**LEGAL ADVERTISEMENT
PORTLAND PLANNING BOARD MEETING**

AGENDA PORTLAND PLANNING BOARD MEETING

Re: Level III Site Plan; 230 Commercial Street (Widgery and Union Wharves);
Proprietors of Union Wharf, Applicant
Project #: 2016-137 CBL: 031 K 003 & 103; 031/L/035, 038 & 135

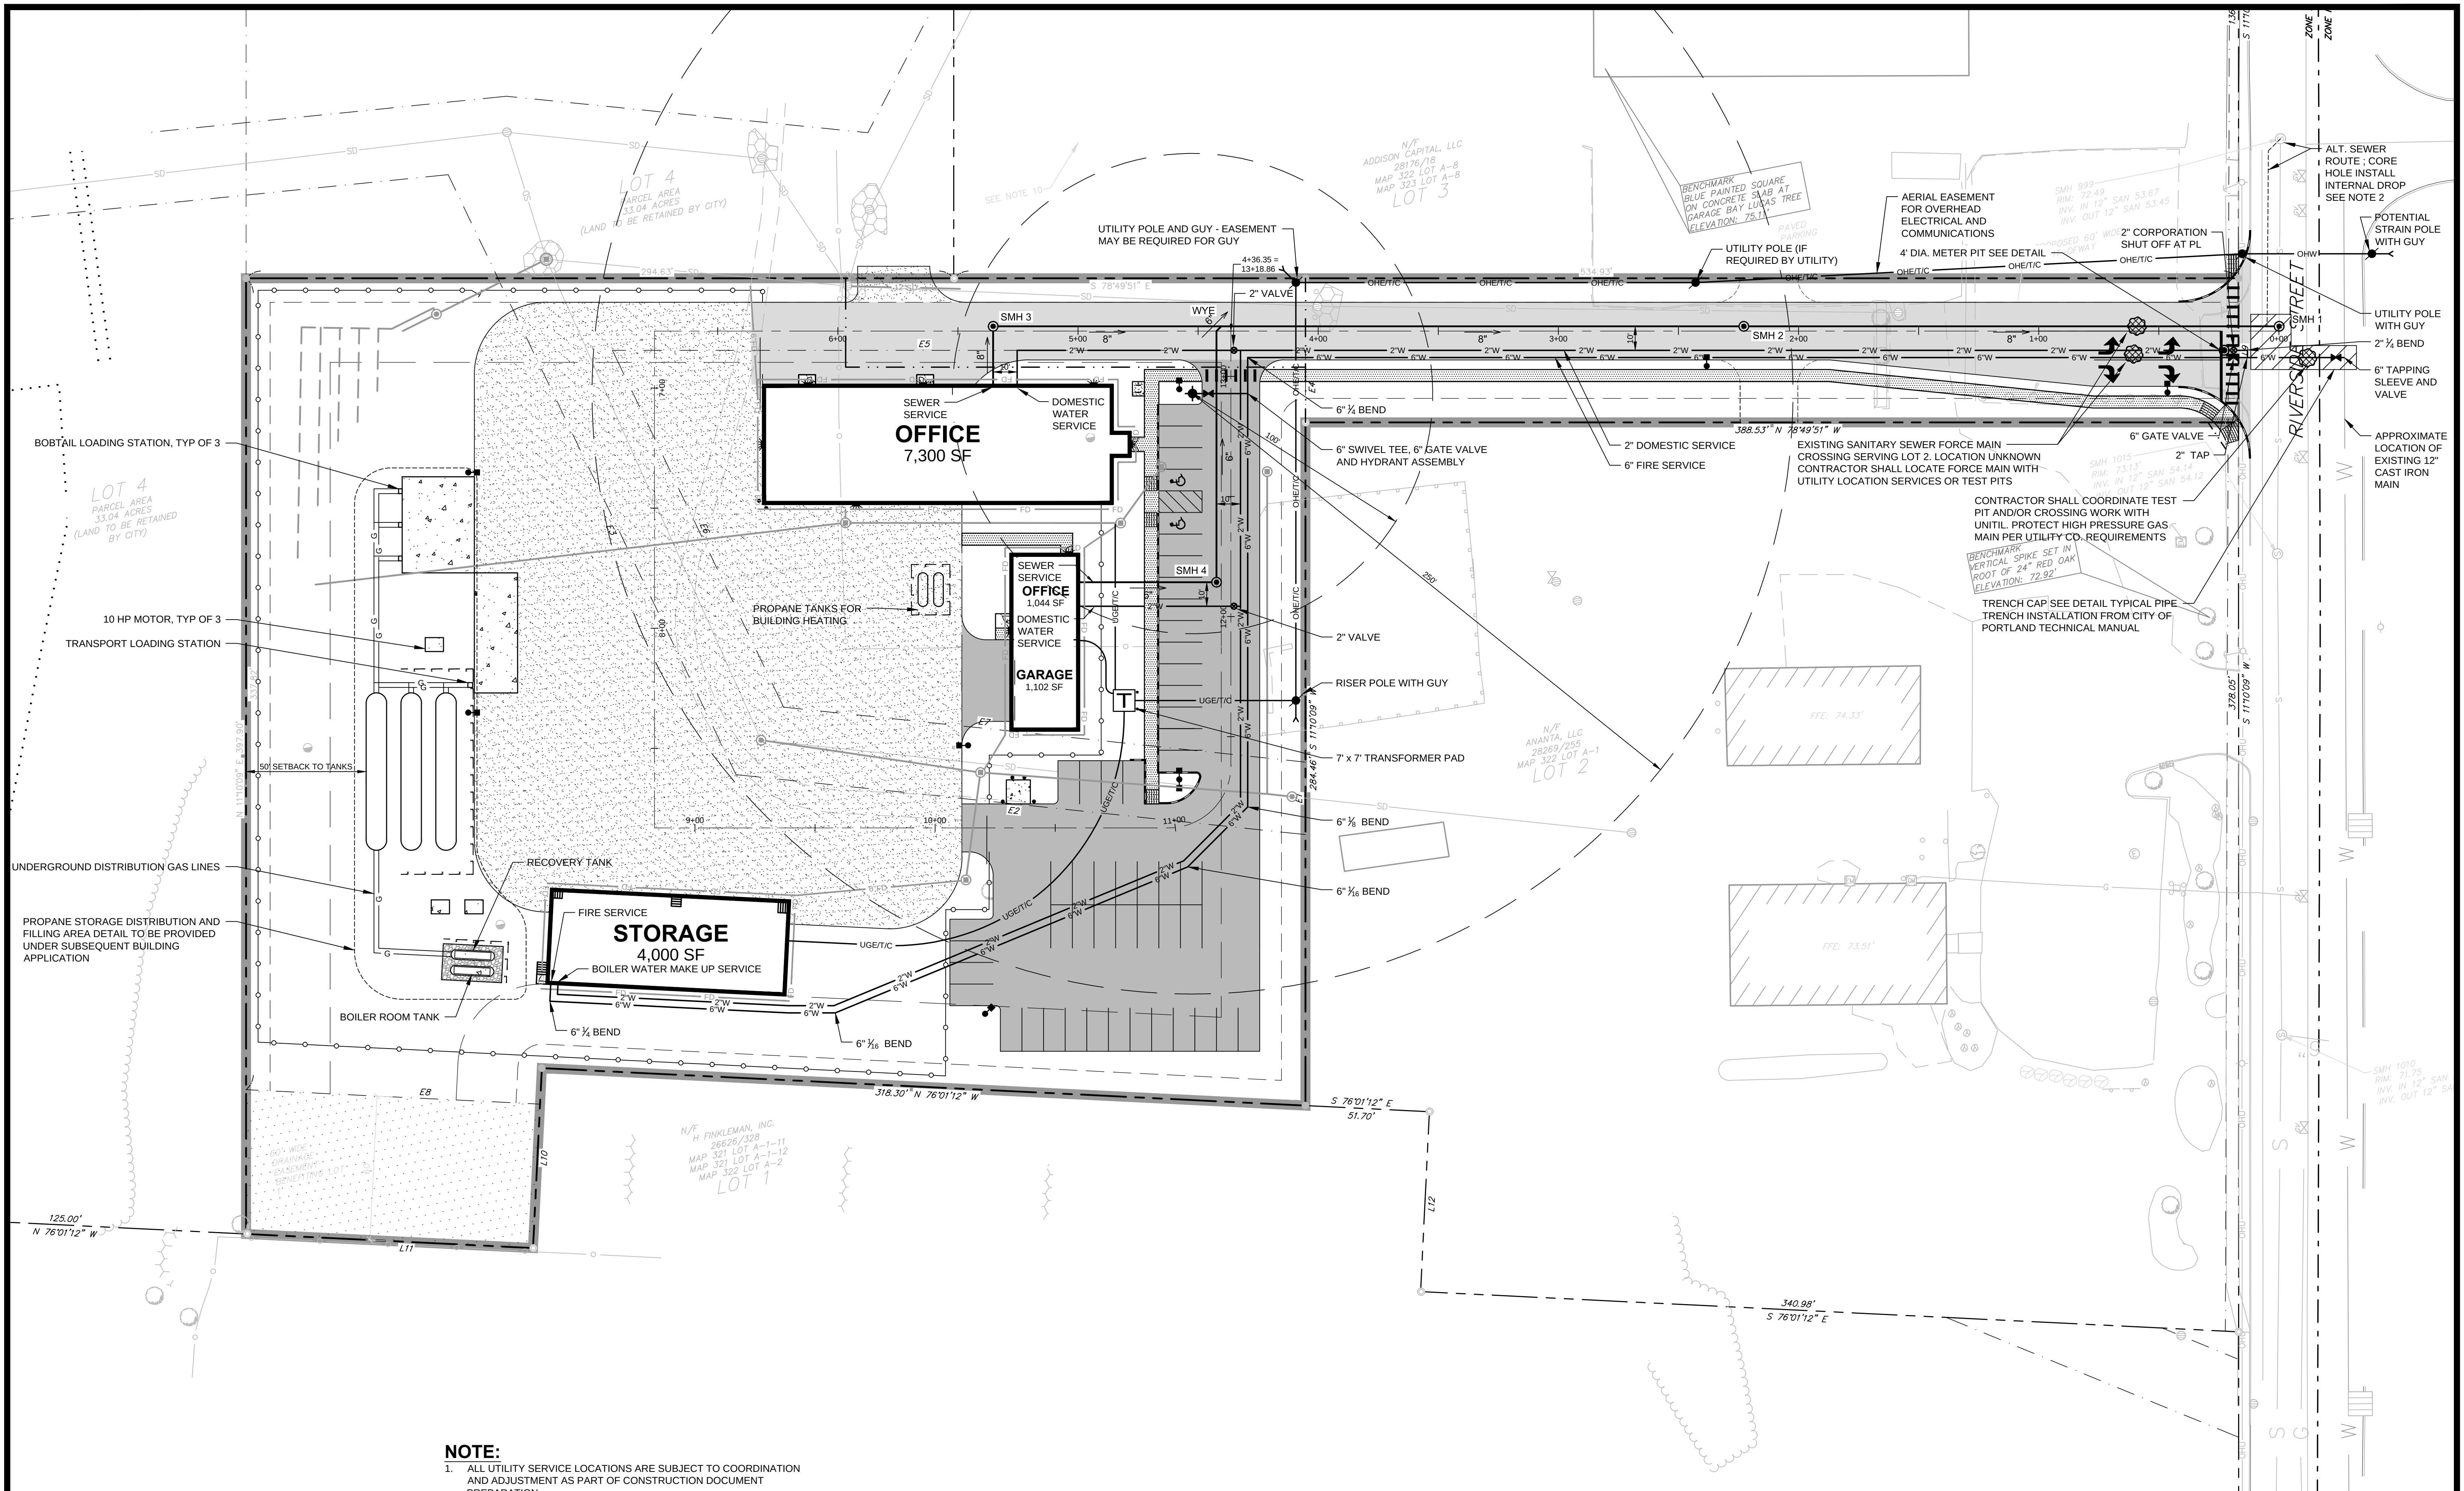
The plans should show pavement repair limits (saw-cuts) for utility installations within Riverside Street, and the details should include Figure II-12 (Typical Pipe Trench Installation) from the City of Portland Technical Manual.

A trench cap repair area has been added to the utility plan and the City of Portland "Typical Pipe Trench Installation detail" has been added to sheet C-8.0.
